## REQUEST FOR SARA RESPONSE

### LOT 2, CAPTAIN COOK HIGHWAY, PORT DOUGLAS

SARA reference: 2503-45404 SRA  
Council reference: CA 2025\_5732/1  
Applicant reference: C1302

## SARA referral agency response – Captain Cook Highway, Port Douglas

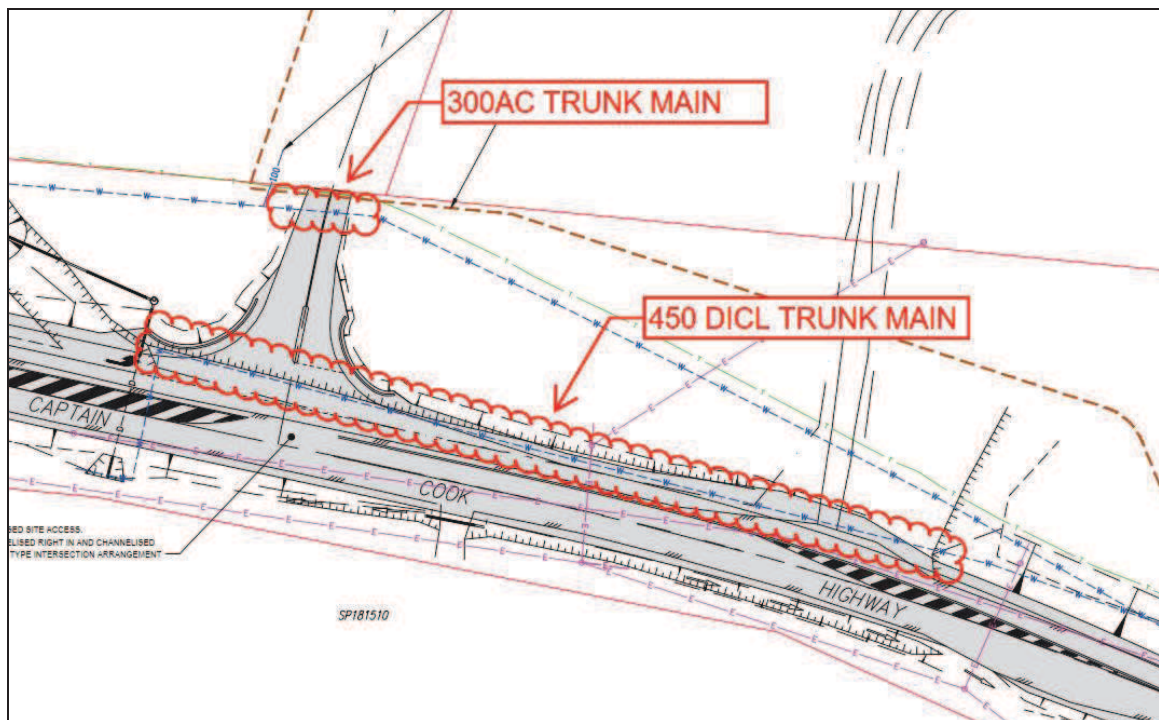
4. Please provide an Engineering Report, prepared by a suitably qualified RPEQ Engineer demonstrating how the site will be connected to Council's sewerage system in accordance with FNQROC Development Manual. The following information is requested:

- a. A concept level sewerage connection plan showing the alignment of the sewer from the site to the connection point with Council's system, specifying whether it will be pressure or a gravity system and indicate the pipe size.

- b. Calculations of expected sewerage generated by the development must be in accordance with FNQROC unless substantiated by appropriate detailed studies.
- c. The Report is to include an internal sewerage service plan for the site including details of levels and capacities for internal gravity sewers.

- d. In-principle approval from the Department of Transport and Main Roads and evidence of consent from any private landowners for the proposed alignment;
- e. Engineering Assessment of the capacity of Council's sewer system to receive the sewer from the development at the proposed connection point and any upgrades required to Council's system as a result of the development.

5. Please clarify the private pump station will be located on the applicant's land and will subject to the achievement of a separate ERA.

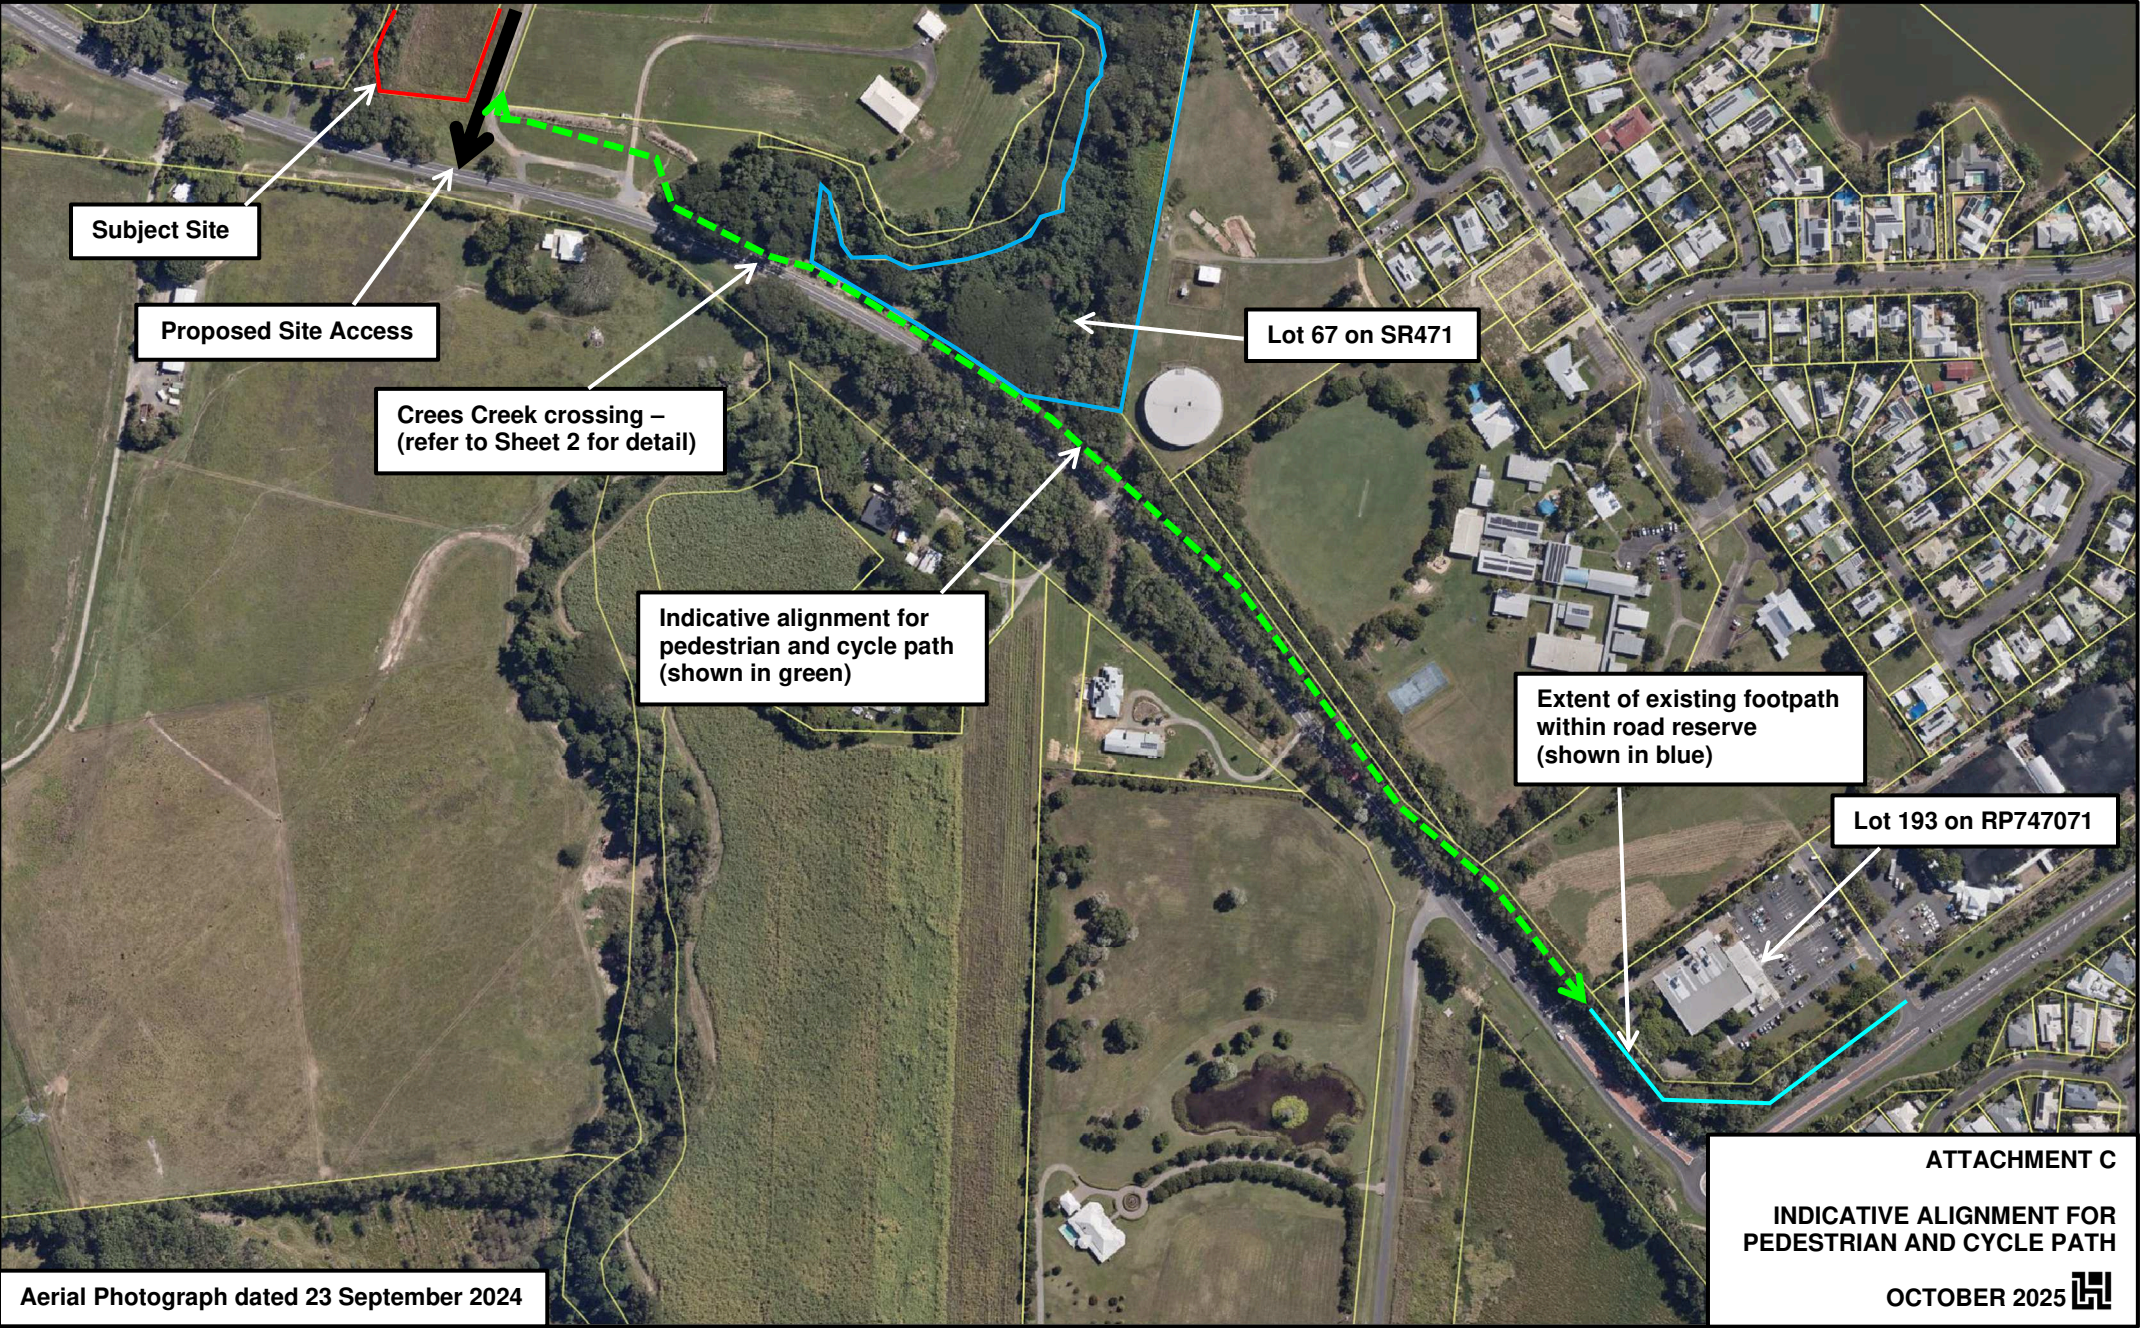
The proposed intersection upgrade shown on Drawing C01, shows that a 140m length of the 450 DICL trunk main will be located beneath the road pavement (figure below). This is undesirable for maintenance and repair of the watermain. Relocation of the main to be outside of the road pavement or a protection measure (e.g. concrete encasement) may be warranted depending on the alignment and cover depth of the pipe relative to the finished surface.

The driveway access leg of the intersection crosses a 10m length of the 300 AC trunk main (figure below). Replacement of the main in DICL or protection measures (e.g. concrete encasement) may be warranted depending on the alignment and cover depth of the pipe relative to the finished surface.

- c. Undertake potholing of the existing 450 DICL and 300 AC water mains to confirm their alignment in relation to the proposed roadworks and the likely depth of cover to the finished surface. Submit the potholing results to Council to review and decide in relocation or protection is required.
- d. The report needs to confirm the level of risk associated with the impact on Council's network, of the proposed connection to Council's trunk main and advise on the acceptability of such risk. The report is to provide advice on how the level of risk can be reduced or mitigated.

ATTACHMENT C  
CREES CREEK CROSSING  
AND SITE ACCESS PLAN  
OCTOBER 2025

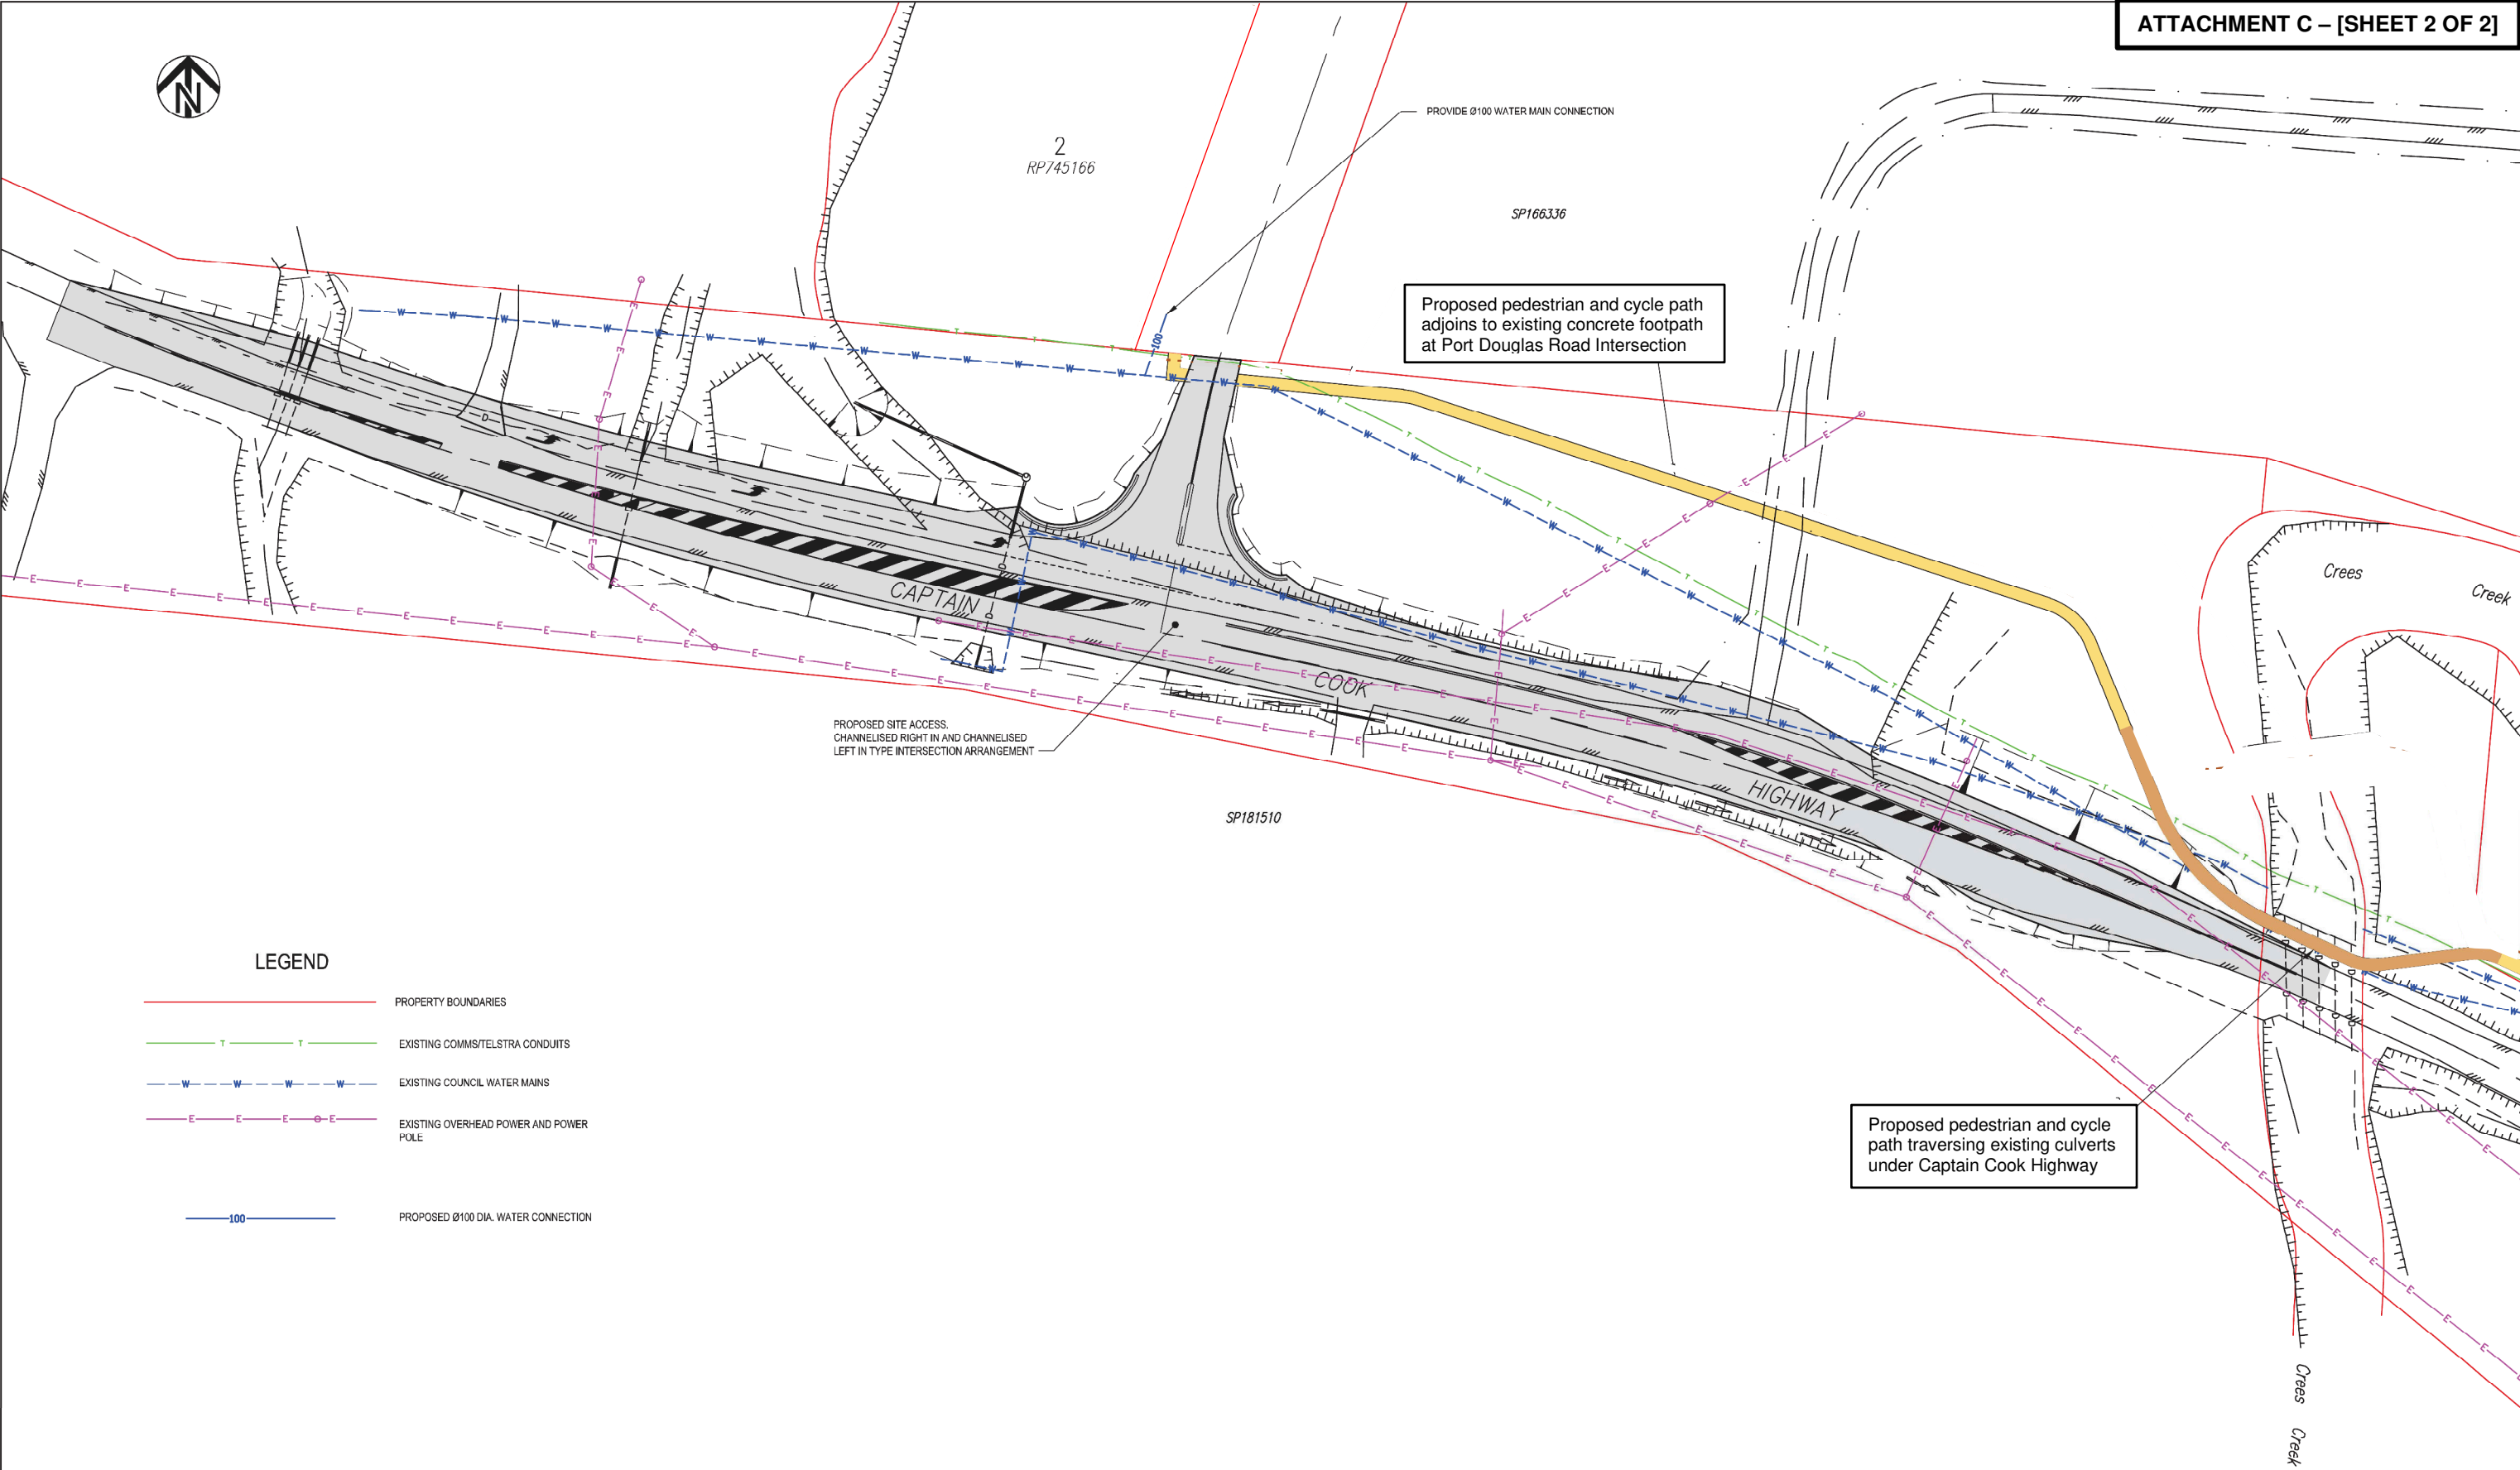
In response to Items 8 and 9 for the Pedestrian / Cycle Connectivity section of the Council Information Request (refer **Attachment B**), it is proposed to construct a pedestrian and cycle path within the State-controlled Road corridor from the subject site to the existing path located at the Captain Cook Highway and Port Douglas Road intersection to the south-east and adjacent to Lot 193 on RP747071. This pedestrian and cycle path will be located on the northern side of the highway.

The proposed alignment of the pedestrian and cycle path includes the construction of an extension to the existing culvert crossing over Crees Creek to enable pedestrian and cycle movement.

The proposed pedestrian and cycle path alignment between the subject site and the existing path adjacent to Lot 193 on RP747071 within the Captain Cook Highway road reserve is shown by Sheet 1 – Indicative Alignment for Pedestrian and Cycle Path Plan and Sheet 2 – Crees Creek Crossing and Site Access Plan attached as **Attachment C**.

Having regard to the Referral Agency Response dated 16 May 2025, written confirmation is sought from SARA that the proposed pedestrian and cycle path to be constructed in the State-controlled Road Corridor (Captain Cook Highway) is acceptable to SARA and DTMR and that in-principal approval can be provided by the Department of Transport and Main Roads.

- a. Pedestrian and cycleway alignment – I can confirm that the Department of Transport and Main Roads (DTMR) have provided in-principal support to the intended pedestrian and cycle path alignment shown on plans provided at Attachment C. I refer to advice items 2 and 3 of the attached SARA referral agency response in relation to further approvals required from DTMR for ancillary works (i.e. paths or bikeways) that are to be undertaken within a state-controlled road corridor.

1. Pedestrian and cycleway alignment – I can confirm that the Department of Transport and Main Roads (DTMR) have provided in-principal support to the intended pedestrian and cycle path alignment shown on plans provided at Attachment C. I refer to advice items 2 and 3 of the attached SARA referral agency response in relation to further approvals required from DTMR for ancillary works (i.e. paths or bikeways) that are to be undertaken within a state-controlled road corridor.
